Re: Woods of Shavano &  
University Oaks

WOODS OF SHAVANO & UNIVERSITY OAKS  
DEVELOPMENT PLAN #19

INFORMATION SHEET FOR  
PRELIMINARY OVERALL AREA DEVELOPMENT PLAN  
(P.O.A.D.P.)

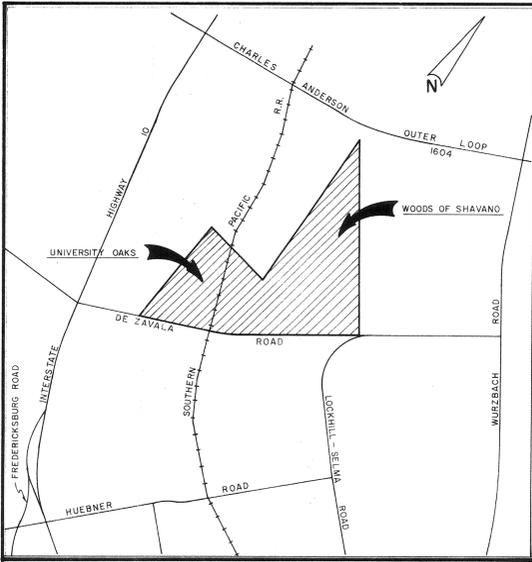
This is to inform you that the revision to the Preliminary Overall Area Development Plan (POADP) for the above captioned subdivision has been reviewed by staff. Staff poses no objections to the amendment reflecting the stub street as recommended by staff. Although, not initially mentioned in staffs previous comments, and if not already planned, it will be necessary to upgrade the subject stub street to a collector status. This is attributed to the collection of vehicular traffic from the Woods of Shavano area which will ultimately carry traffic to the planned Lockhill Selma thoroughfare.

2-21-84  
Advised committee  
of changes was  
objection was  
repaired. Advised  
committee that  
R.O. had already  
app. the R.O.D. app.  
preliminary and was  
pending final app.  
purpose of revised plan was  
to update P.O.A.P.
